Access Compliance Report Public Rights-of-Way (Curb Ramps)

Main Street: REDLANDS_DR **Cross Street:** UNIVERSITY_DR **Location:** SE

ADA ID: RPRK211018111130 **Ramp Type:** Type 4 - Parallel **Initial Pass/Fail:** Fail **Overall Compliance:** No **Severity Score:** 2

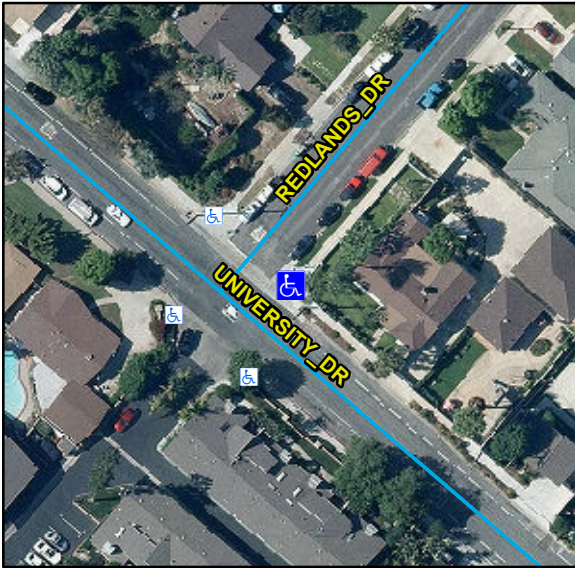
Compliance	Description	Data	Compliance	Description	Data
N/A	Ramp Length LT (in)	98	N/A	Ramp Length RT (in)	98
Yes	Ramp Width LT (in)	103	Yes	Ramp Width RT (in)	102
Yes	Ramp Run Slope LT (%)	4.8	Yes	Ramp Run Slope RT (%)	3.3
Yes	Ramp Cross Slope LT (%)	1.8	No	Ramp Cross Slope RT (%)	2.8
N/A	Landing Present	N/A	N/A	DWS Provided	N/A
N/A	Landing Length (in)	N/A	N/A	DWS Contrast	N/A
N/A	Landing Width (in)	N/A	N/A	DWS Length (in)	N/A
N/A	Landing Run Slope (%)	N/A	N/A	DWS Full Width	N/A
N/A	Landing Cross Slope (%)	N/A		DWS Offset Type	N/A
N/A	Landing Movement Obstructed?	N/A	N/A	DWS Offset Left (in)	N/A
	Landing Movement Type	N/A	N/A	DWS Offset Right (in)	N/A
N/A	Landing Shared	N/A			
N/A	Clear Space	Yes			
N/A	Clear Space To Crosswalk (in)	N/A			
N/A	Marked Crosswalk 1	No	N/A	Marked Crosswalk 2	No
	Crossing 1 Direction	NW		Crossing 2 Direction	SW
	Marked Crosswalk 1 Width (in)	N/A		Marked Crosswalk 2 Width (in)	N/A

Possible Solutions:
Remove & Replace Curb Ramp With Two New Directional Ramps or Equivalent.
